Rezoning Transportation Analysis
Petition Number: Insert Zoning Petition #2021-226
General Location Identifier: 02902129, 02902130

Revision Log:

Date	Description
02-24-22	First Review (PDM)
03-24-22	Second Review (PDM)

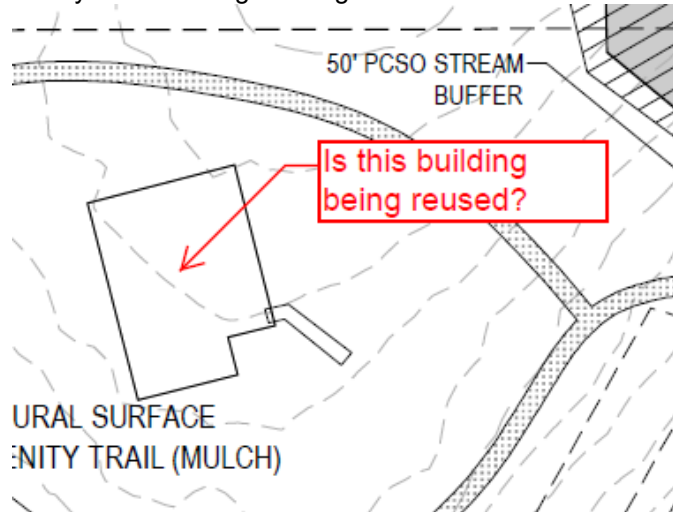
2. Revise site plan and conditional note(s) to commit to dedicate 30-feet of right-of-way from the road centerline of Galloway Road. The site plan shall label and dimension the right-of-way from the road centerline. Callout the proposed right-of-way line as "Proposed ROW."

Outstanding Comment from 02.24.2022: Add centerline of roadway to Galloway Road and callout the proposed right-of-way line as "Proposed ROW".

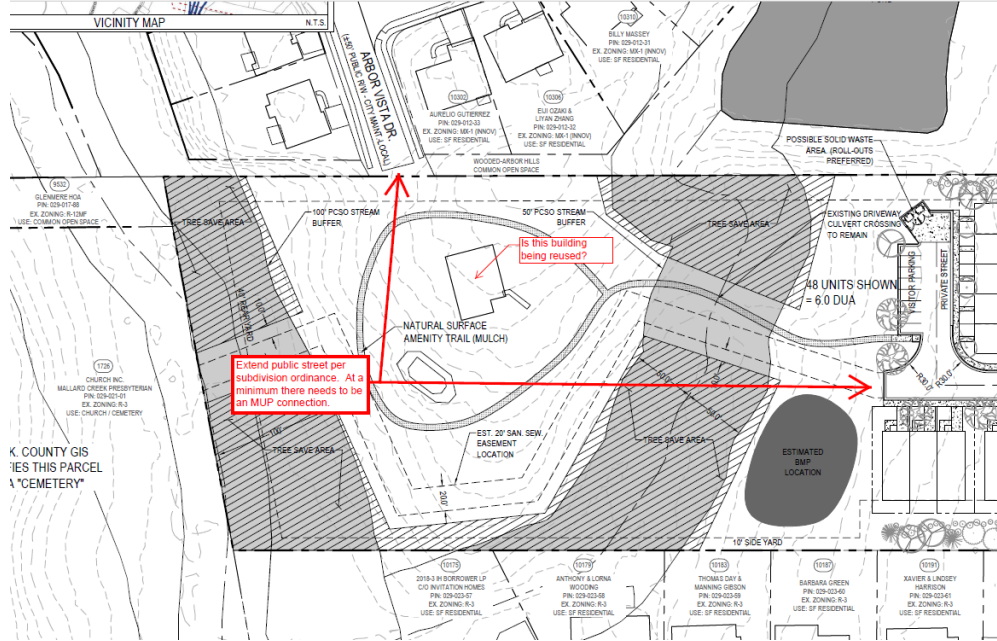
- Revise site plan and conditional note(s) to commit to construct a 12-foot multi-use path that connects the Arbor Vista Drive stub street to the proposed street per Chapter 20. Provide a public access easement for the multi-use path route. CDOT may request the existing Arbor Vista Drive be extended with a public road if the existing building will be removed.

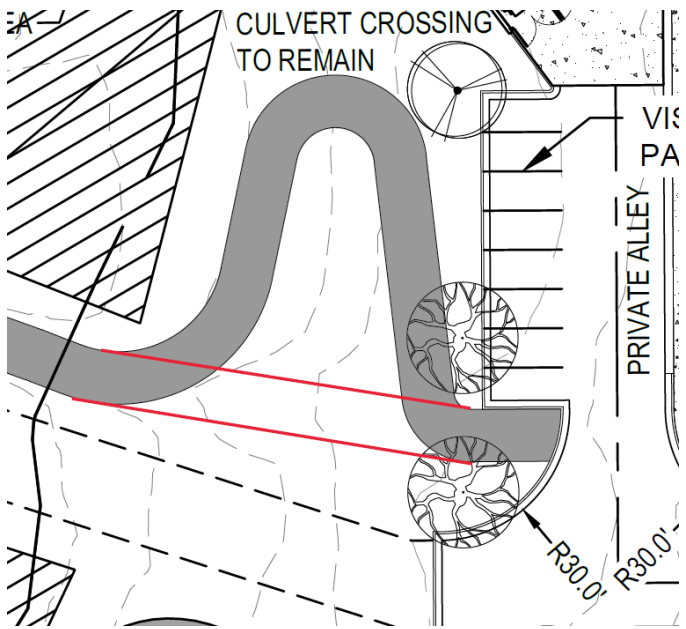
Outstanding Comment from 02.24.2022: Provide a public access easement for the multi-use path route. In addition, CDOT recommends stairway/path connecting MUP.

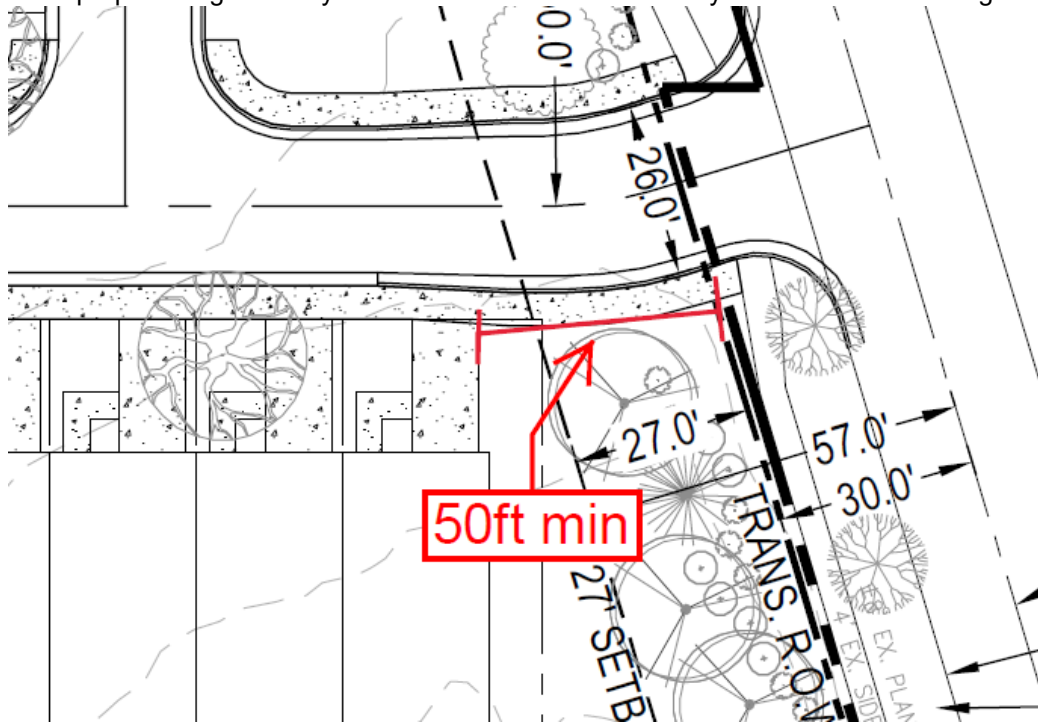
- 6. **Outstanding Comment from 02.24.2022:** Revise site plan to provide a minimum 50-foot stem between the proposed right-of-way and the first residential driveway. Dimension stem length.

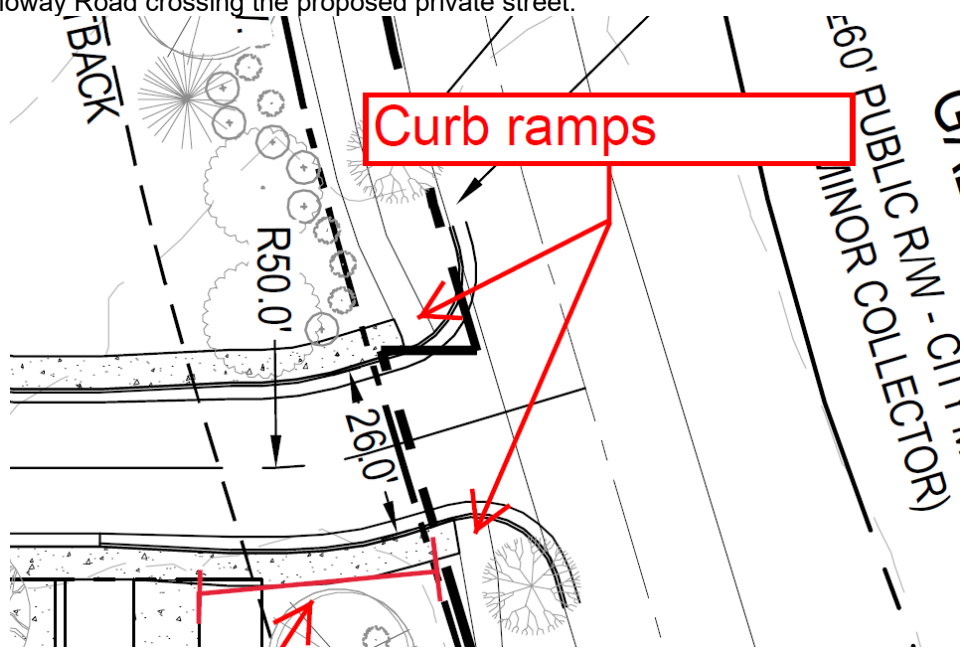
- 7. **Outstanding Comment from 02.24.2022:** Revise site plan to provide curb ramps for the sidewalk along Galloway Road crossing the proposed private street.
